Regulation No. 27 (Advance warning triangle)

Proposal for the 04 series of amendments to Regulation No. 27 (Advance warning triangle)

Submitted by the expert from the International Automotive Lighting and Light Signalling Expert Group (GTB)*

"Annex 2

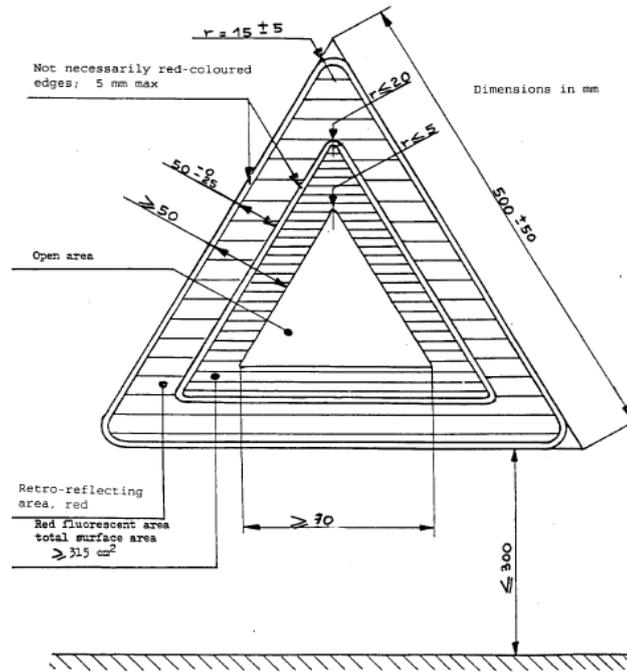
Annex 2, amend to read:

An advance-warning triangle bearing one of the approval marks shown above has been approved in the Netherlands (E4) under approval number **04216**. The first two digits of the approval number indicate that the approval was granted according to the requirements of this Regulation as amended by the **04** series of amendments.

Shape and dimensions of the advance-warning triangle of type 2 and of the support

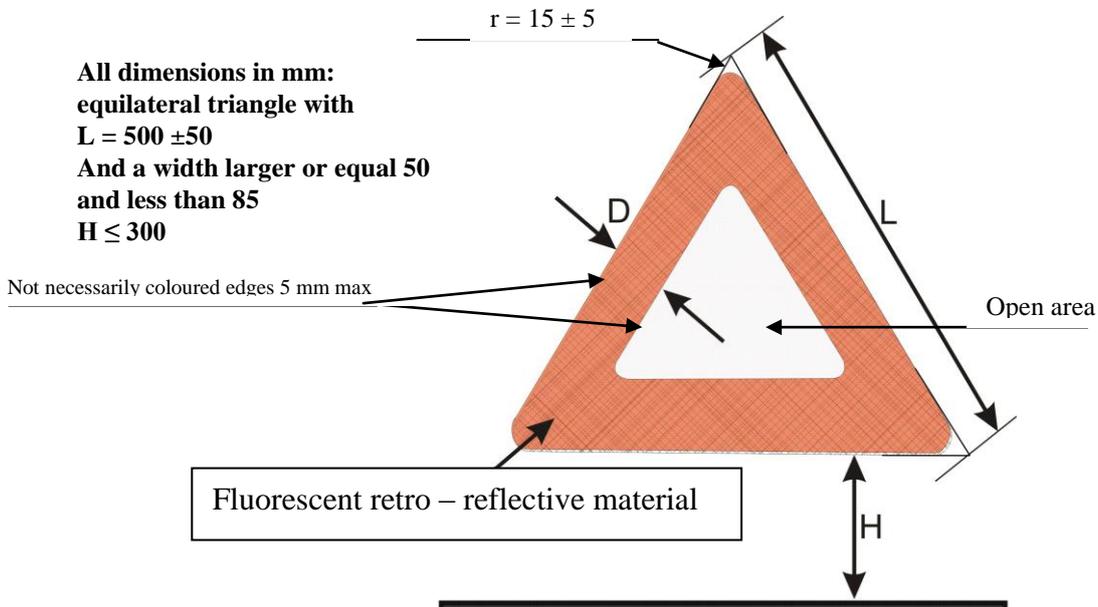
Insert a new Figure 2., to read

"Figure 2-3
Test device for clearance to ground

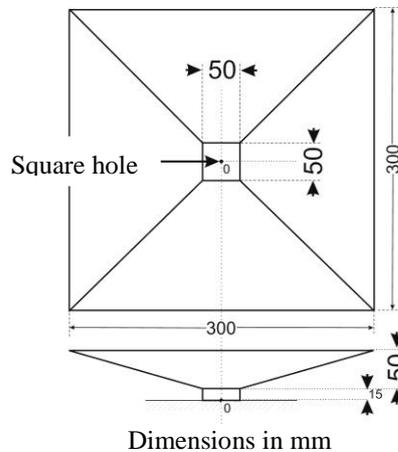
Annex 3, Figure 2., renumber to read Figure No. 3 and amend to read:

- (g) The test device for clearance to the ground in Annex 3 is simplified and only one dimension (300mm) will be applied.
- (h) The Conformity of Production requirements are amended following the approach accepted at sixty-ninth session of GRE (ECE/TRANS/WP.29/GRE/69, item 5(d)).

R 27 Colour Boundaries new proposal

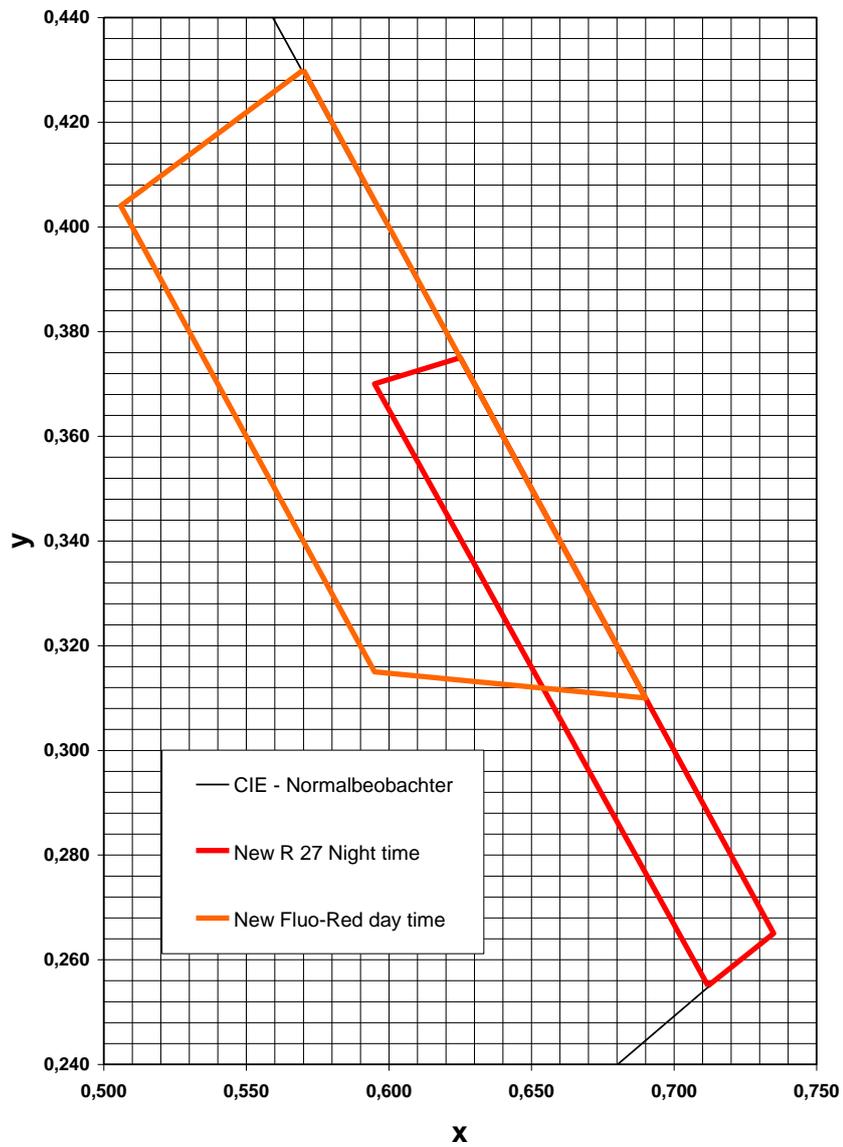
- (a) Revised provisions to combine colour boundaries for the night time colour, i.e. the illumination of the retro-reflectors with the Illuminant A, and for the daytime colour, i.e. the illumination of the fluorescent material with the Illuminant D65. (Please refer to the diagrams shown below.)
- (b) For the colour measurement of fluorescent materials, the old test procedure using the Illuminant C is replaced by the Illuminant D65, as in the Regulations Nos. 69 and 70. The result is that the relevant UN Regulations now have a uniform procedure for carrying out the same measurements.
- (c) For the instrumental measurement of the fluorescent colour, alternative methods are now introduced and allowed.

a) Colour boundaries:
